ADDENDUM No. 1

Hoover, Greene, & Hill Improvement Project

ADDENDUM No. 2

Hoover, Greene, & Hill Improvement Project

FIRE HYDRANT ASSEMBLY
PAID FOR AS FIRE HYDRANT ASSY, W/EXTENSIONS, COMPLETE

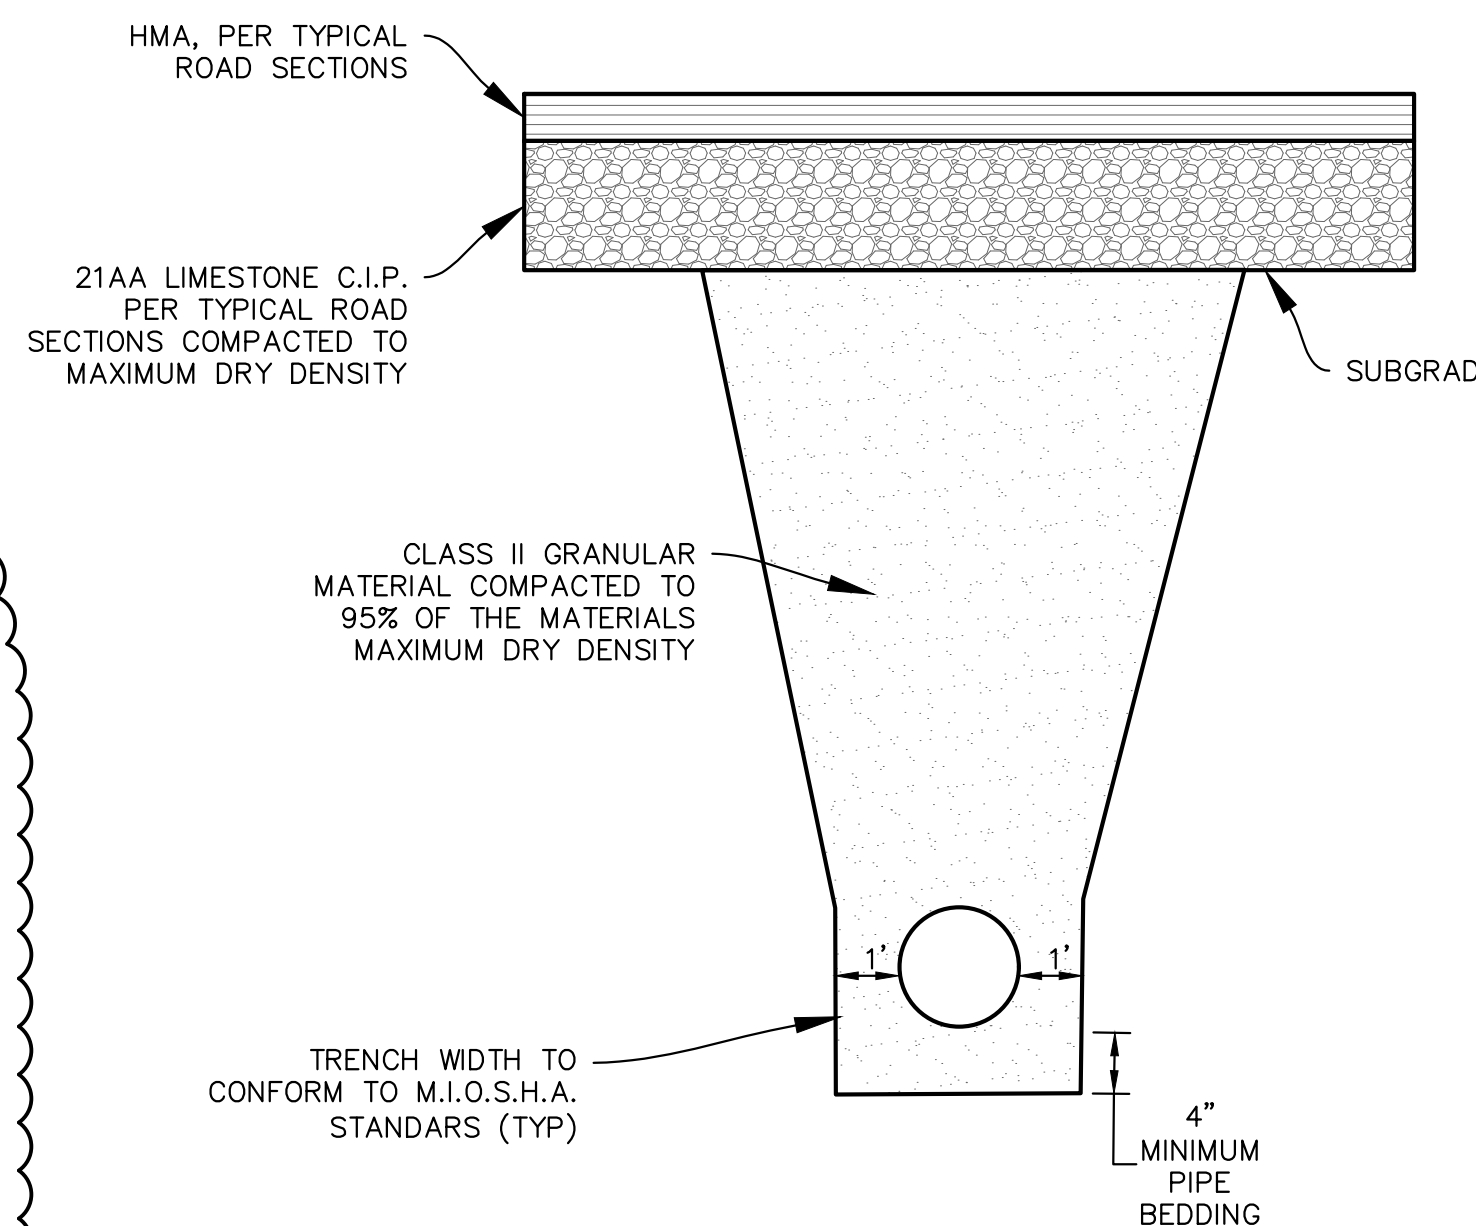
Plan Sheet 21 of 83 Updated detail added for “Fire Hydrant Assy, w/Extensions, Complete” pay item showing push on joints versus mechanical joints.

Answer 8: *The hydrant shoe assembly shall be push joint. The detail on Plan Sheet 21 has*
